**City of Phoenix
Office of the City Engineer
Design and Construction Procurement**

**WS90400085
LIFT STATION 40 REFURBISHMENT**

ADDENDUM NO. 4

ISSUE DATE: December 5, 2025

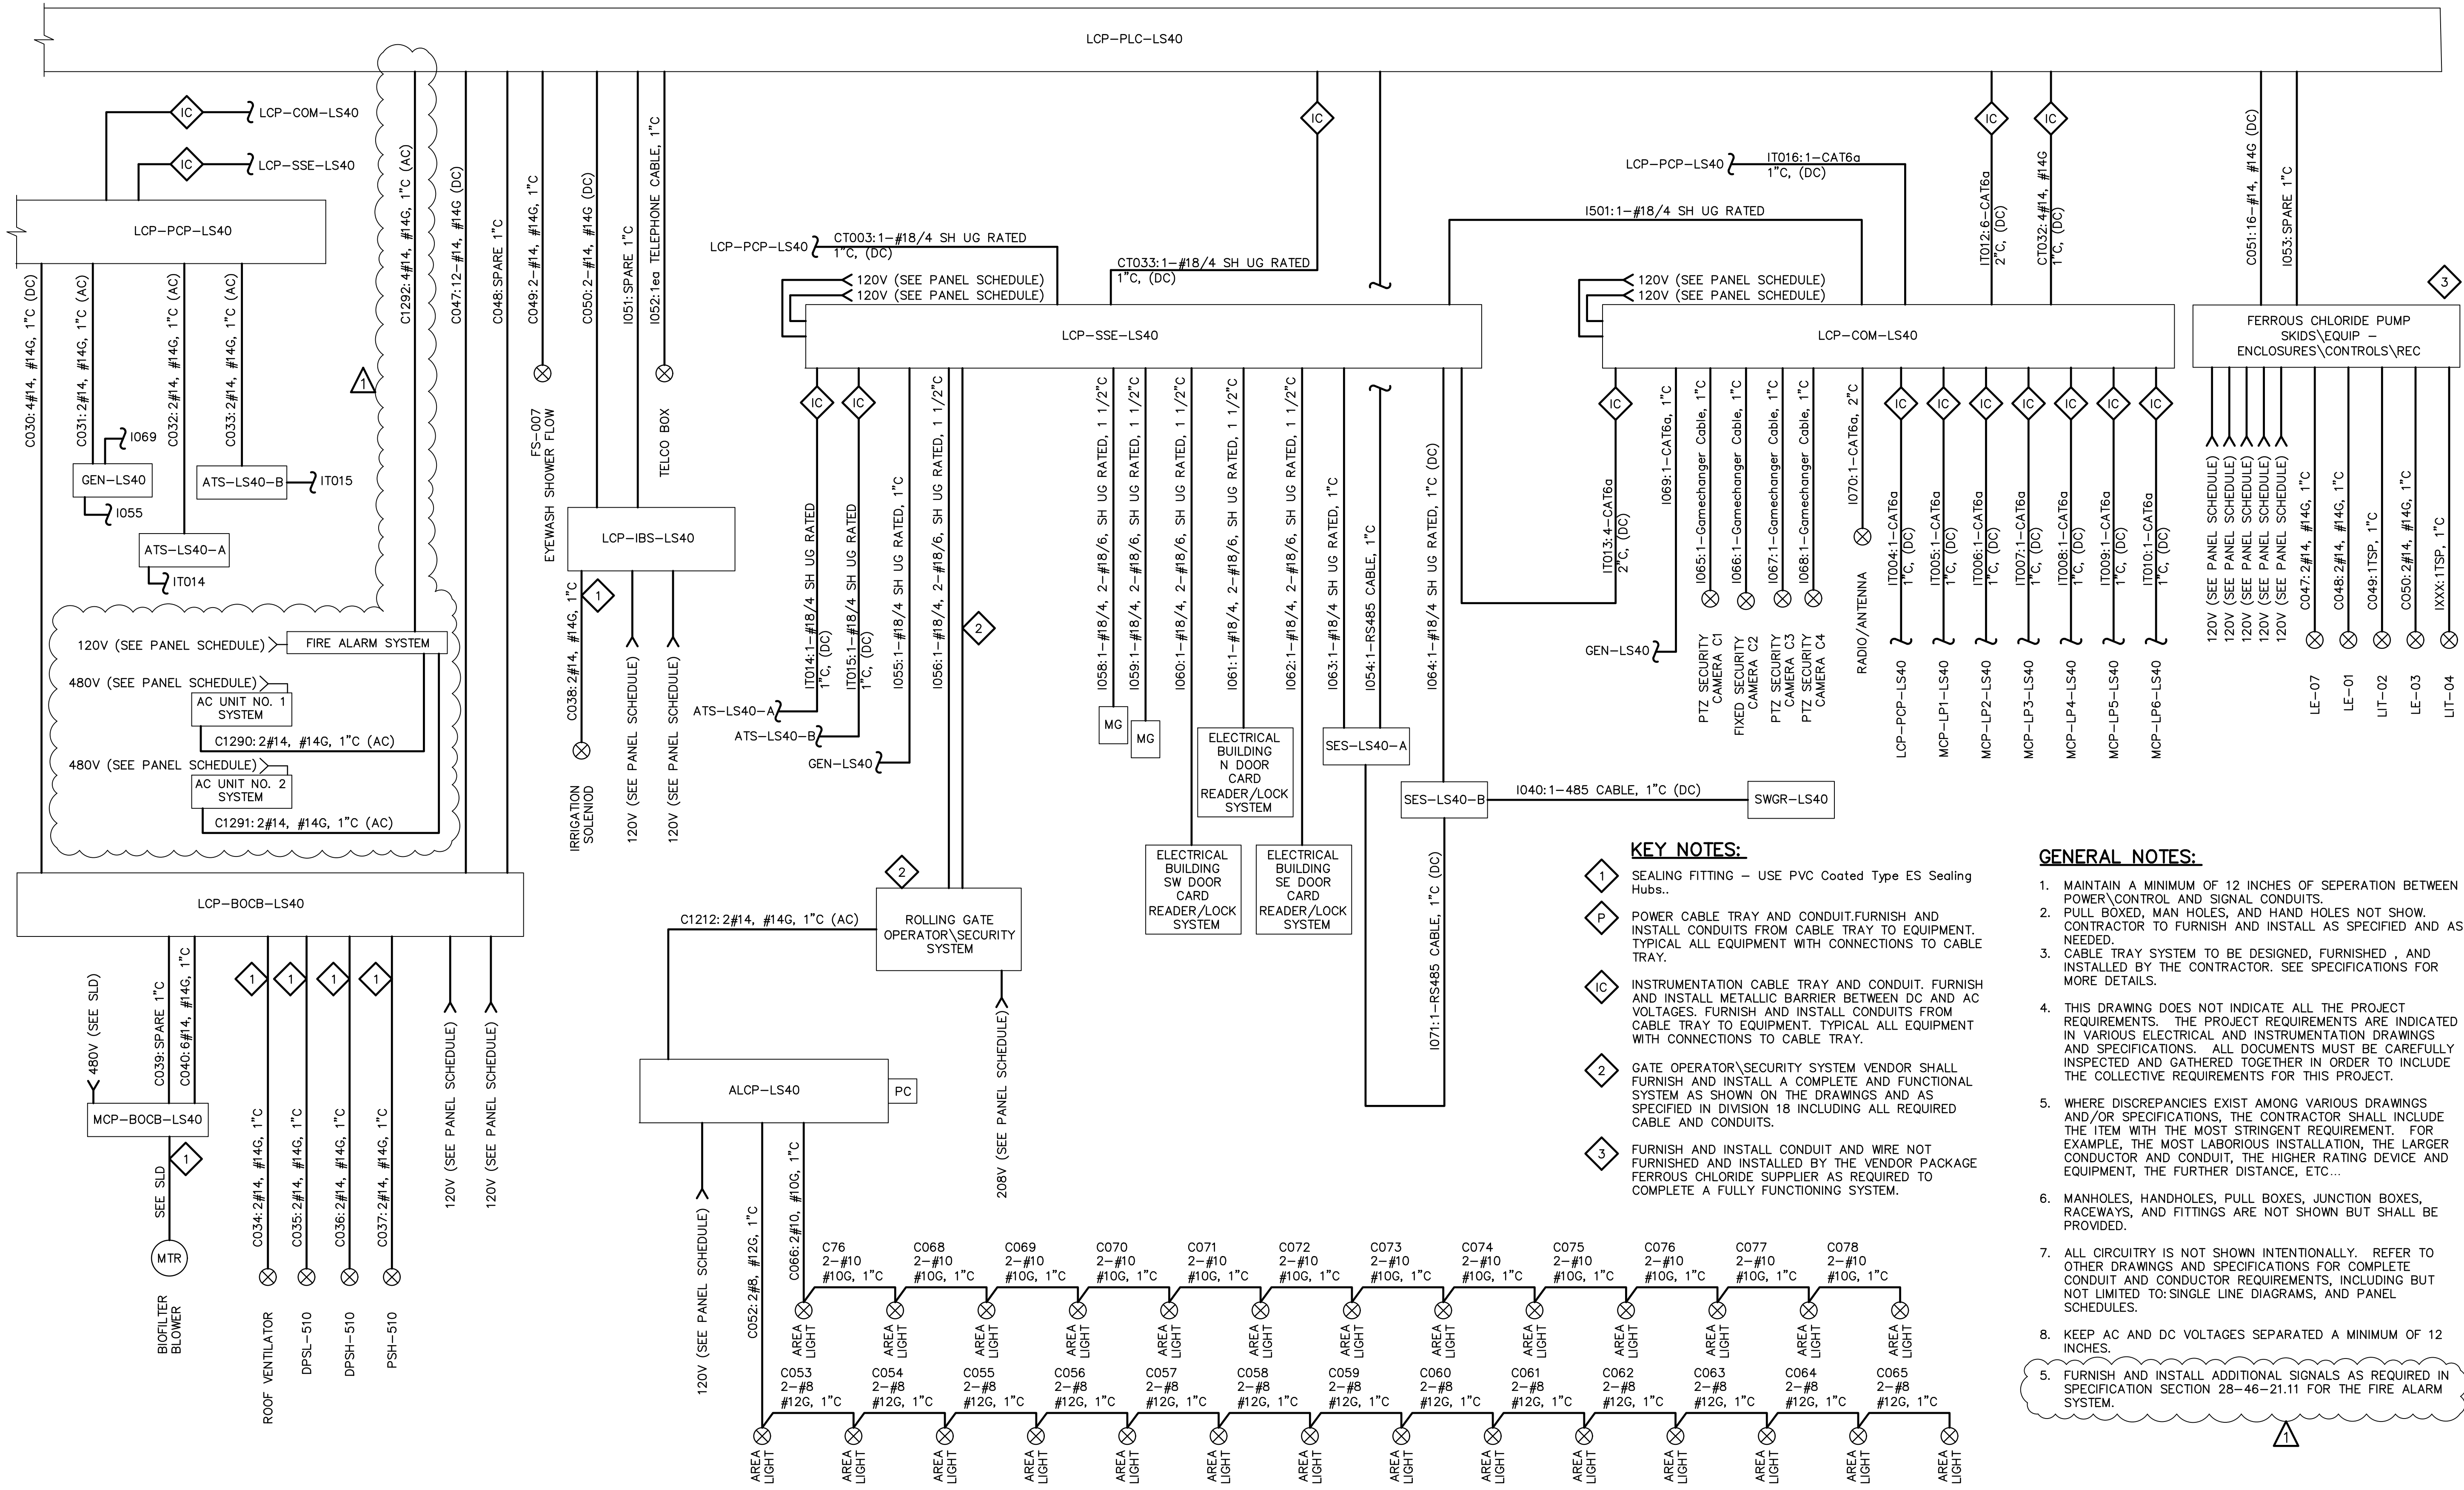
REPLACE: DRAWING E-18 – POWER PANELS SCHEDULE
DRAWING E-27 – CONDUIT BLOCK DIAGRAMS
DRAWING I-06 – P&ID SHEET 3

5. FURNISH AND INSTALL ADDITIONAL SIGNALS AS REQUIRED IN SPECIFICATION SECTION 28-46-21.11 FOR THE FIRE ALARM SYSTEM.

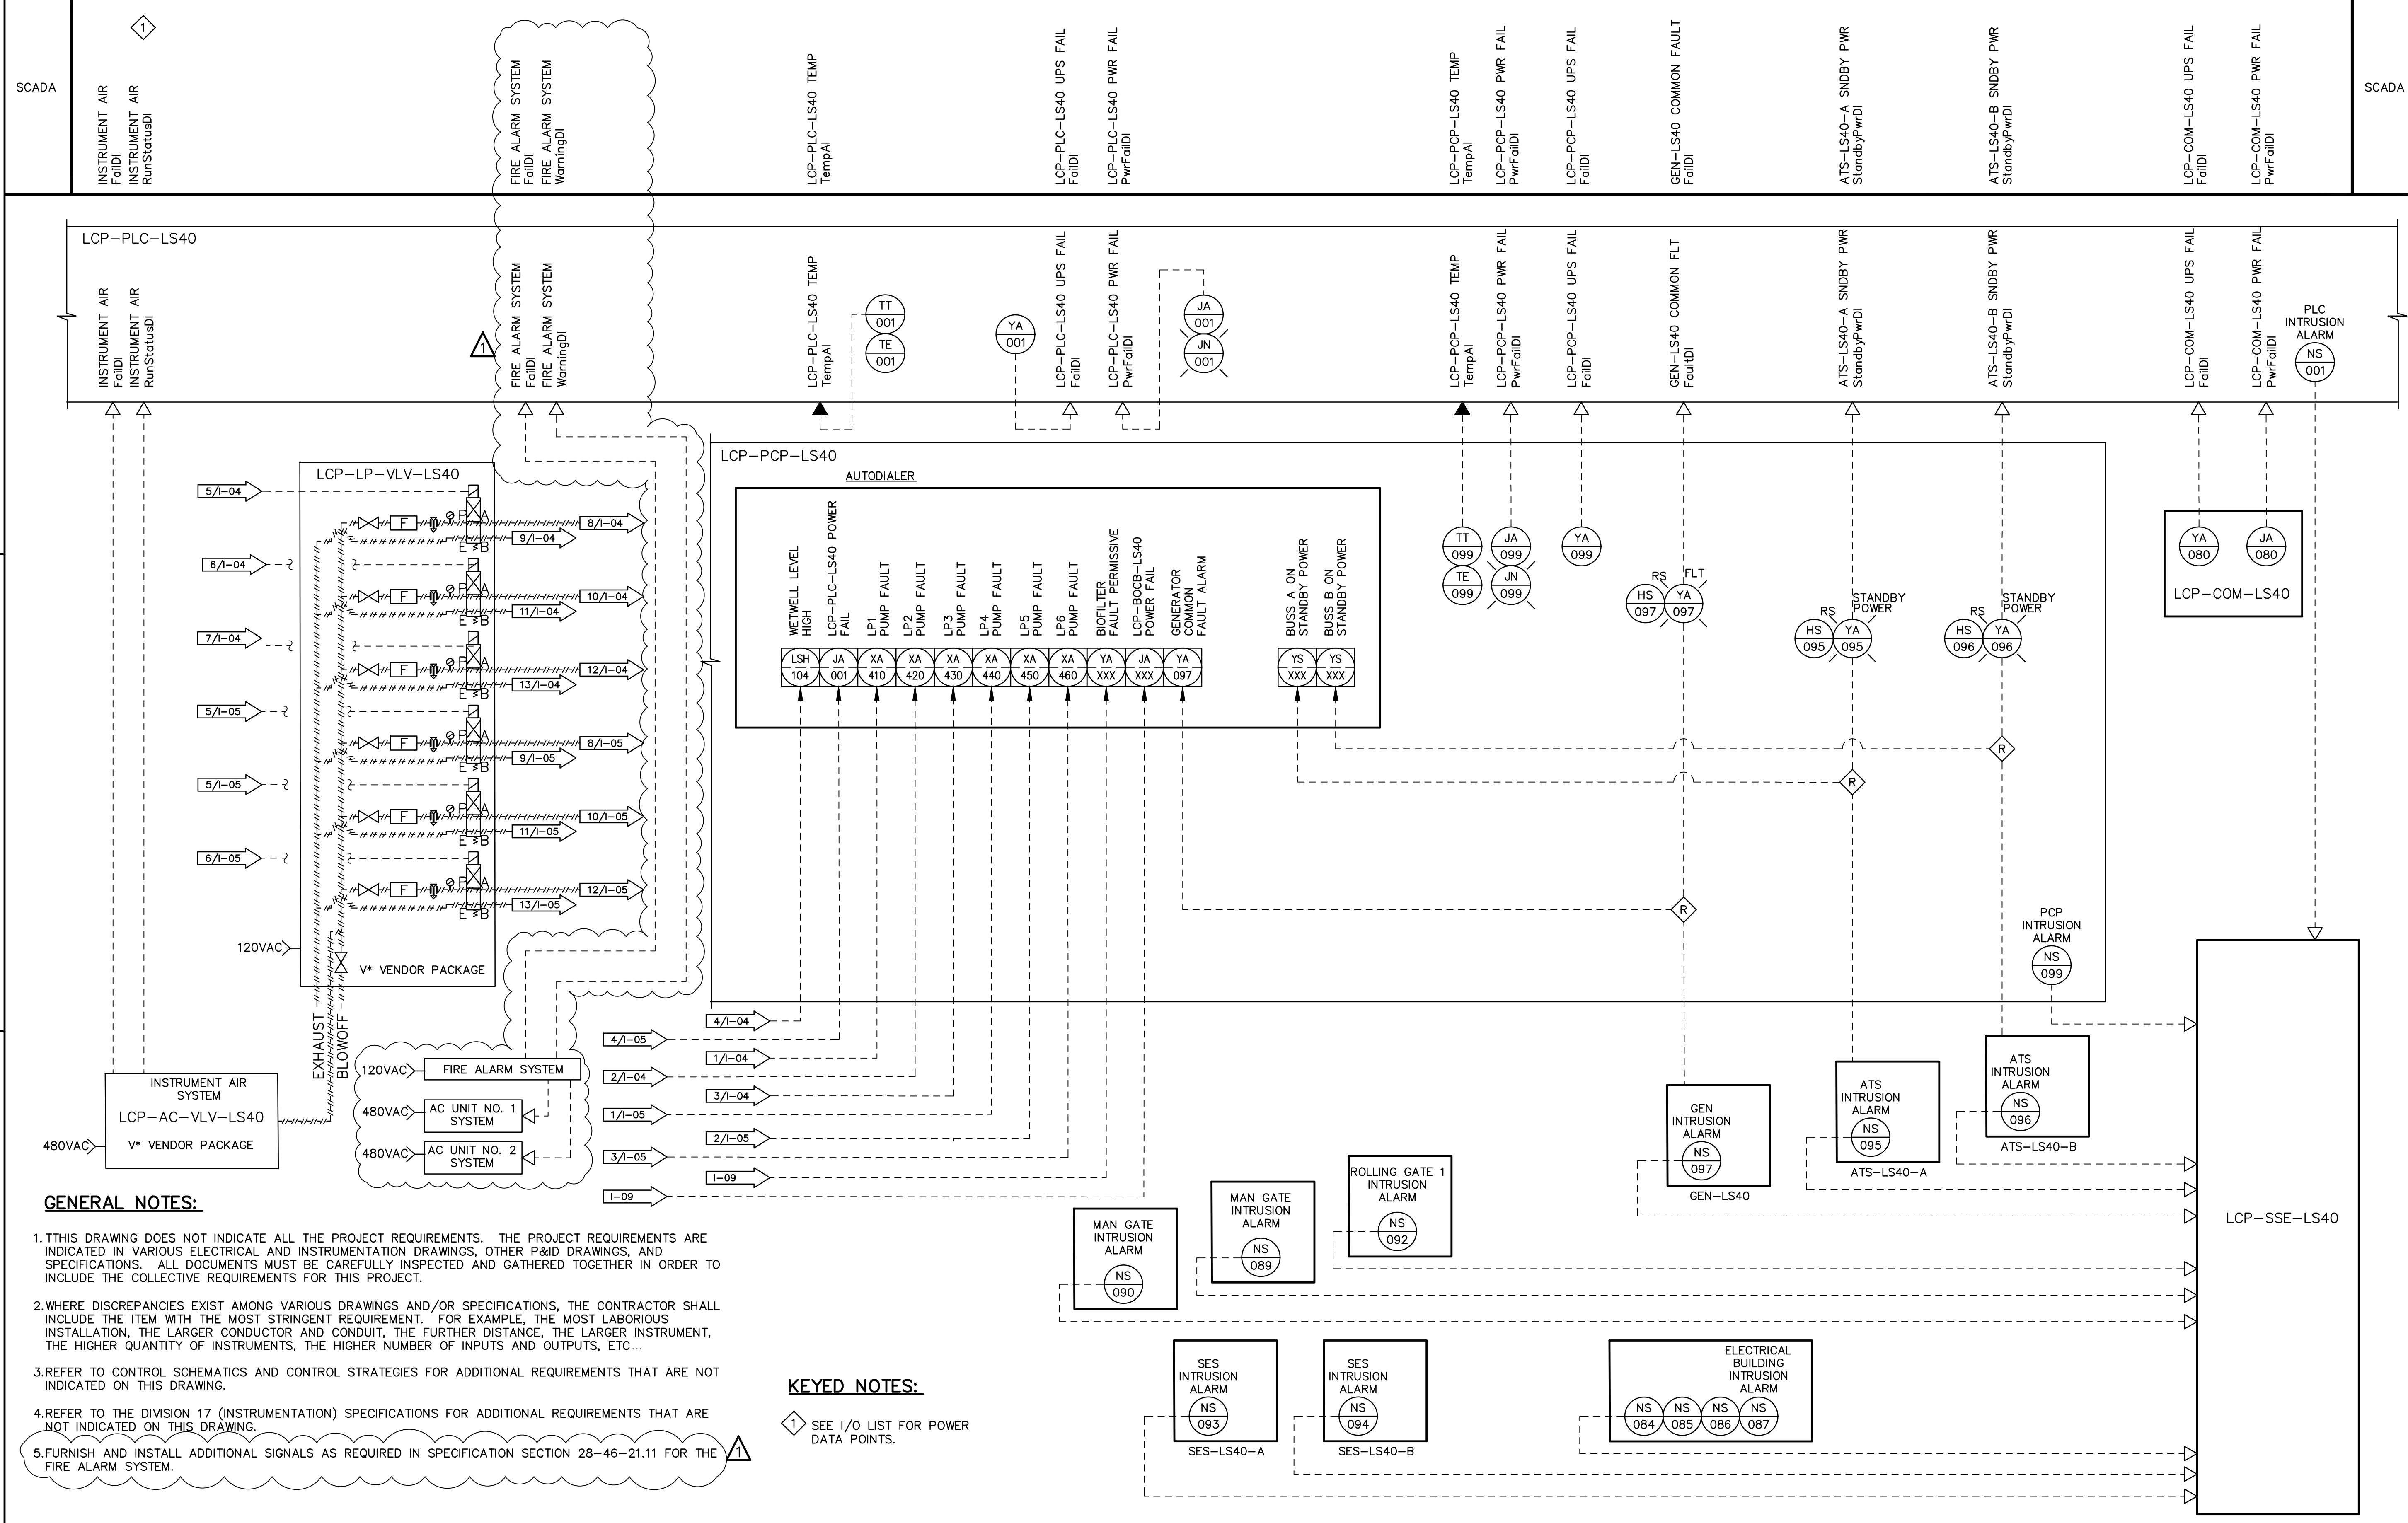
- FURNISH AND INSTALL ADDITIONAL SIGNALS AS REQUIRED IN SPECIFICATION SECTION 28-46-21.11 FOR THE FIRE ALARM SYSTEM.
